**ADDENDUM No. 2**

Date: May 13, 2024  
Project: Roseburg Regional Airport  
Taxiway A Extension  
Bid Date: May 16, 2024

ROSEBURG REGIONAL AIRPORT  
TAXIWAY A EXTENSION  
3896 NW STEWART PARKWAY  
ROSEBURG, OR 97470

1 WING WALL AND RETAINING WALL PLAN  
S-101 SCALE: 1/16" = 1'-0"

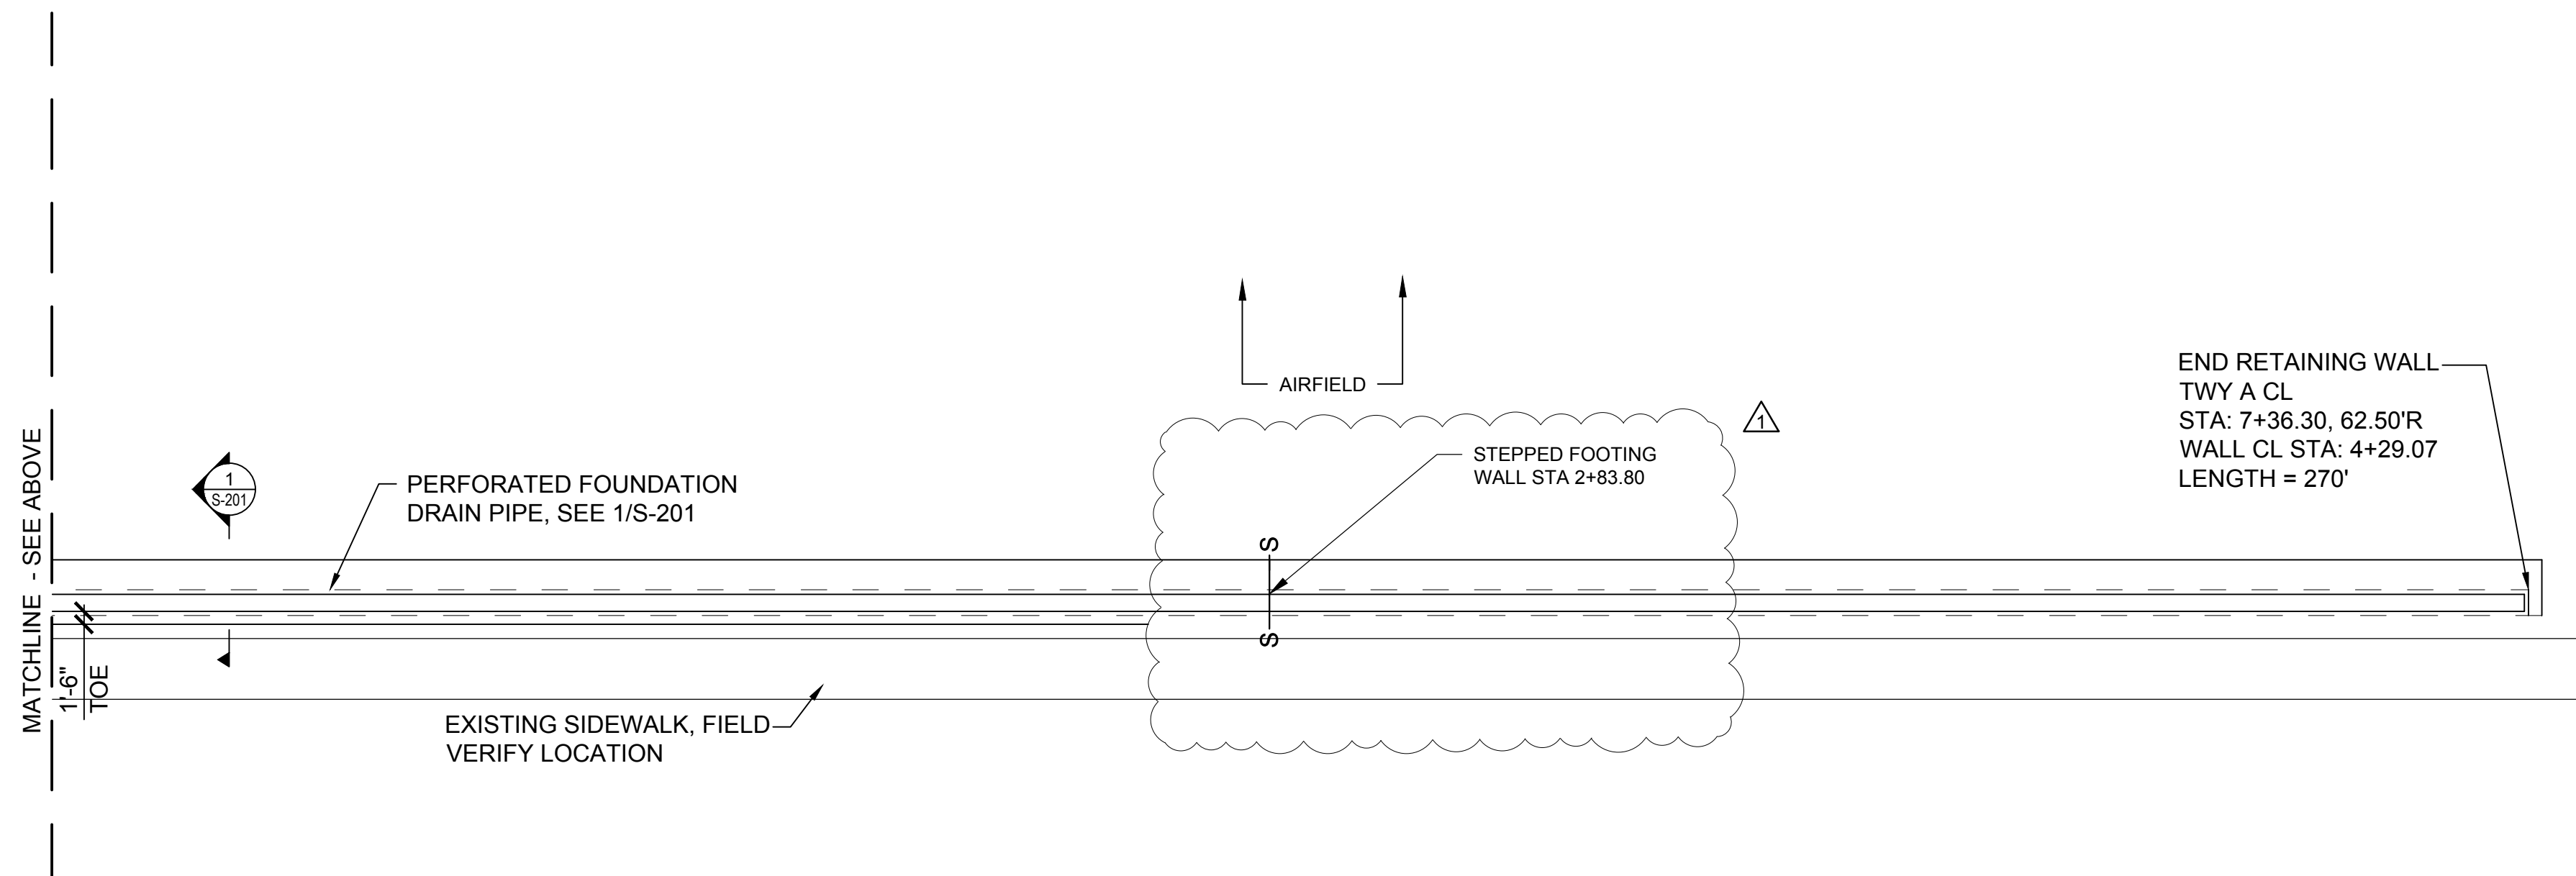
- Replace sheet S-101 in its entirety with Sheet S-101 included under this addendum.  
*Clarification: Adjusted location of retaining wall footing steps.*

**Question:** I can't find the vertical change in footing height at wing wall and retaining wall drawing s-101,102 Can we verify that please?

**Answer:** Sheets S-101, S-102, and S-201 have been reissued under this Addendum.

SHEET CONTENTS  
RETAINING WALL  
PLAN & ELEVATIONS

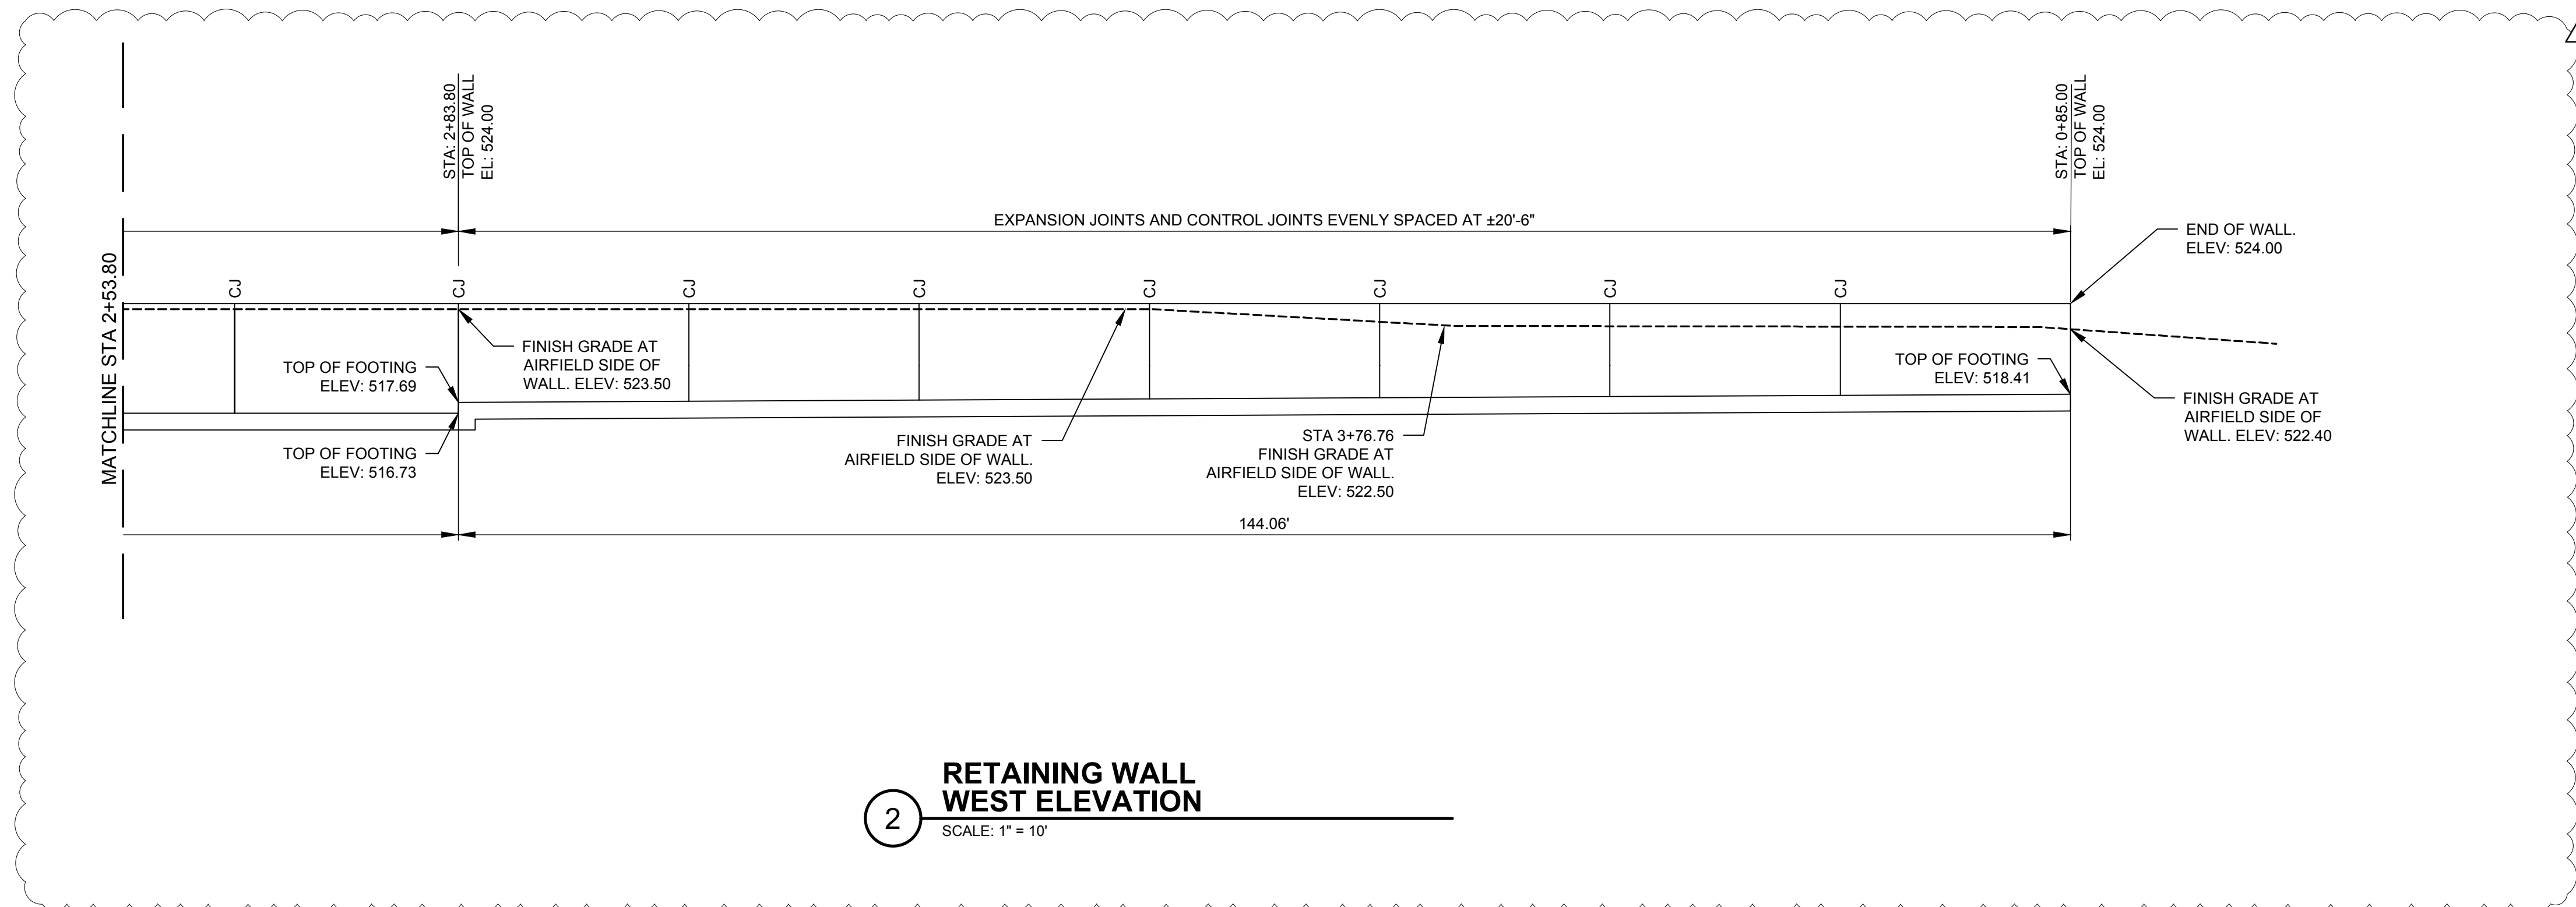
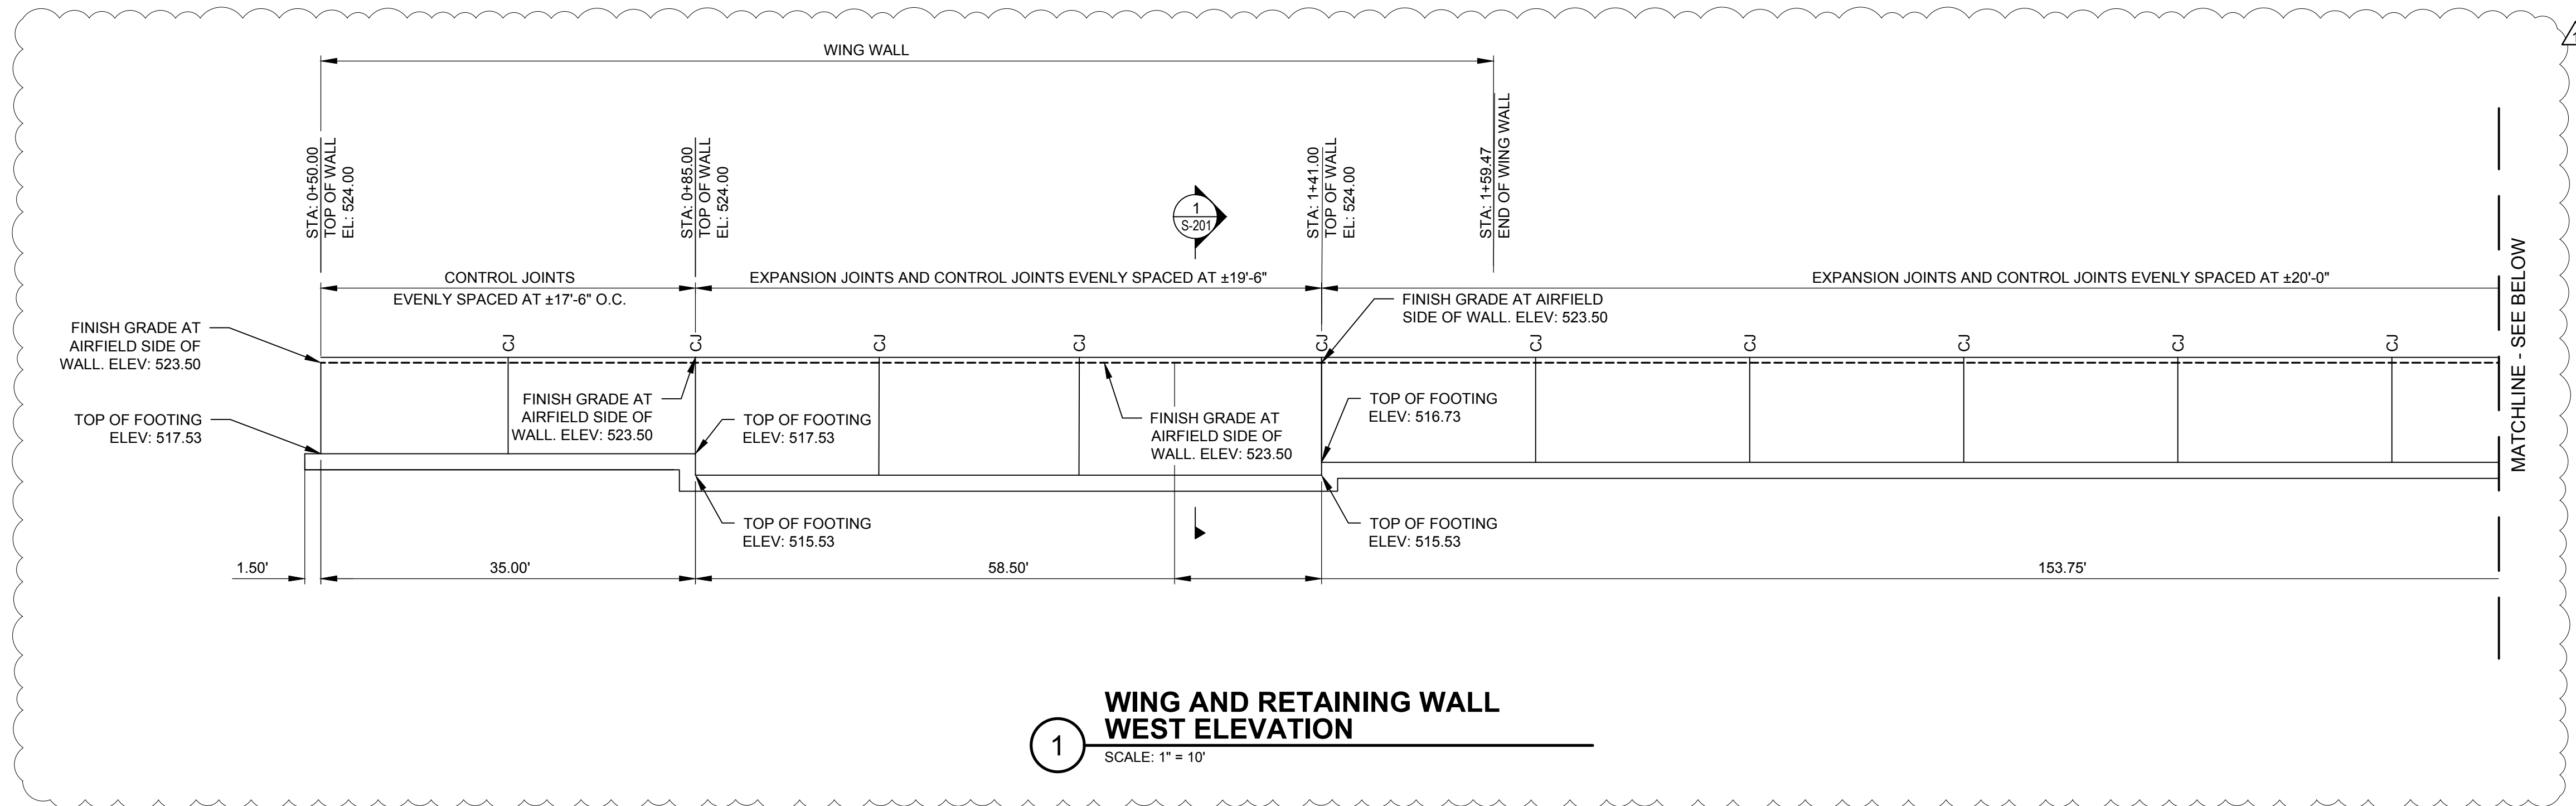
- Replace sheet S-102 in its entirety with Sheet S-102 included under this addendum.  
*Clarification: Revised sheet to show additional info on retaining wall elevations.*

**Question:** Can you add some more footing elevations to the retaining wall sheet S-102. There is no information on the change in step heights. There is only one top of footing grade given but the footing is not continuously the same elevation.

**Answer:** Sheets S-101, S-102, and S-201 have been reissued under this Addendum.

**1 TYPICAL FOOTING**  
S-201 SCALE: 3/4" = 1'-0"

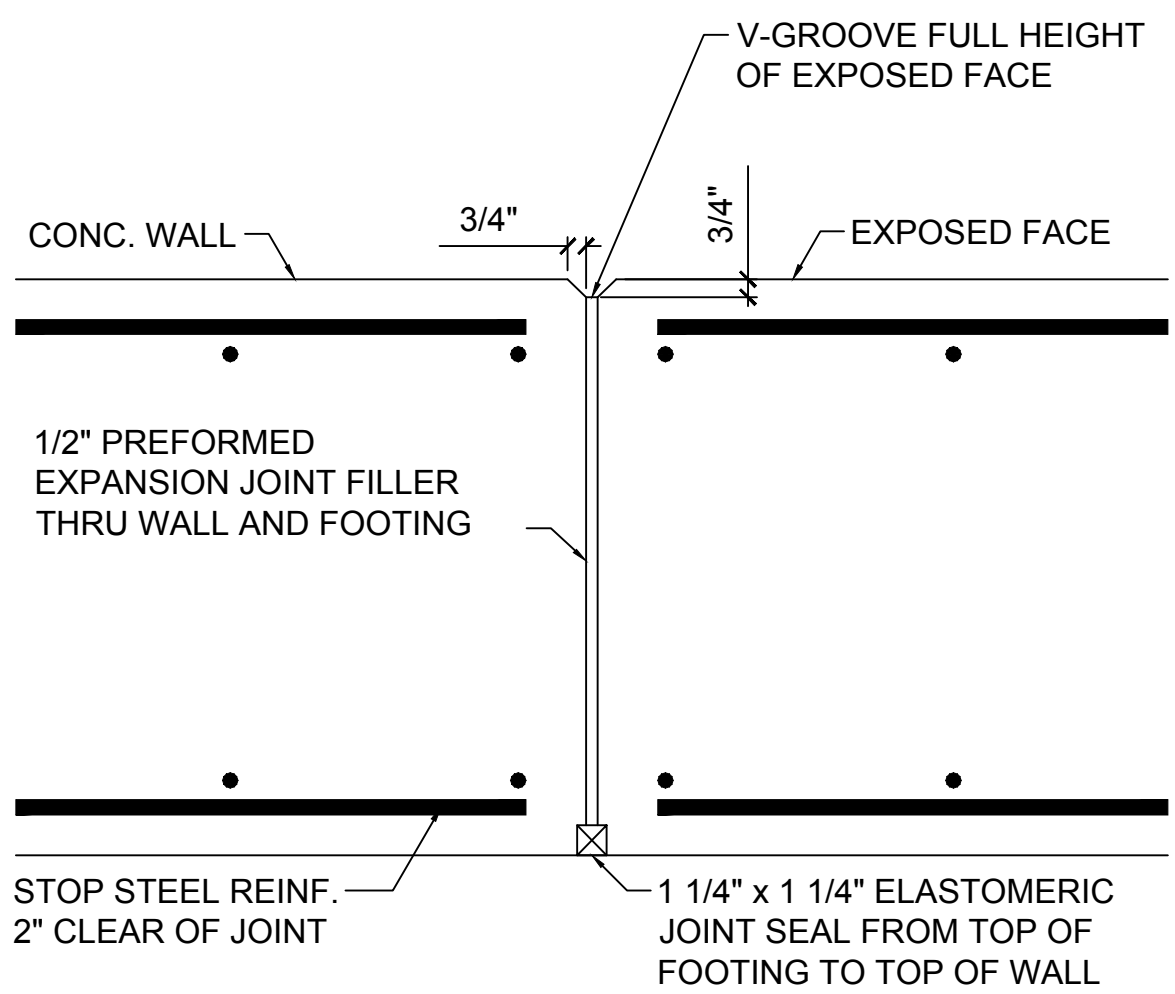
- Replace Sheet S-201 in its entirety with Sheet S-201 included under this addendum.  
*Clarification: Added 8" of P-209 underneath retaining wall.*

**Question:** Looking at the wall sheets and spec section NS-101, it does not show or call out for any base rock under the wall. Am I to assume the concrete will be poured directly on native material?

**Answer:** 8" of P-209 is required. Sheet S-201 has been reissued under this addendum.
